**CMD: 25-M9.A**

Commission Request for Information

***Regulatory Oversight  
Report for Canadian  
Nuclear Power  
Generating Sites: 2023***

The purpose of this supplemental Commission Member Document (CMD) is to provide additional information to what is presented in CMD 25-M9, including:

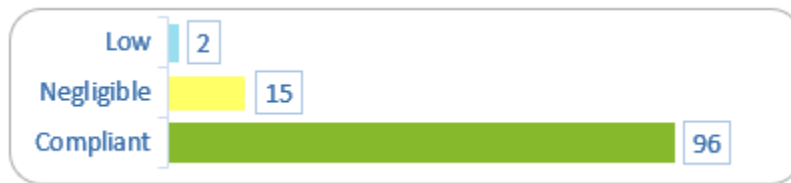
- In section 2.1.6 Fitness for Service for Darlington NPP it is mentioned that: “In 2023, the critical corrective maintenance backlog, deficient maintenance backlog and the number of critical preventive maintenance deferrals were zero.” Instead, the text should state: “In 2023, the critical corrective maintenance backlog, deficient maintenance backlog and the number of critical preventive maintenance deferrals were very low.”
- In section 2.5.1 Management System for Bruce Power the correct number of findings is indicated below:

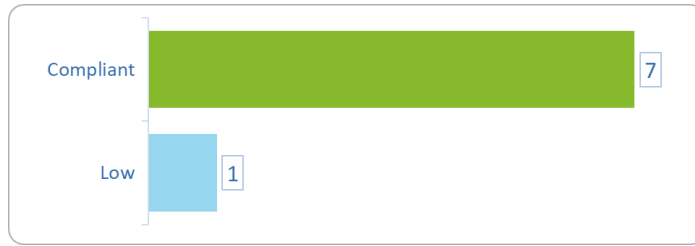
- In Section 2.6.2, Human Performance Management for Western Waste Management Facility, the correct number of compliant findings was two, not three.

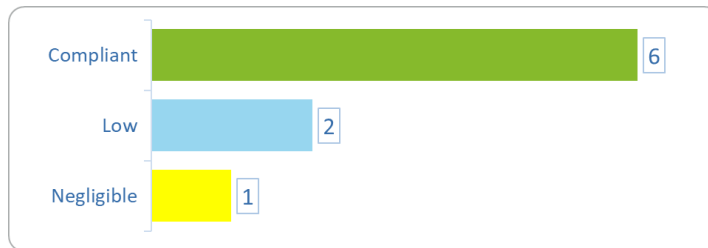
- In Section 2.6.3, Operating Performance for Western Waste Management Facility, the correct number of compliant findings was seven, not six. The corrected version of the chart is shown below:
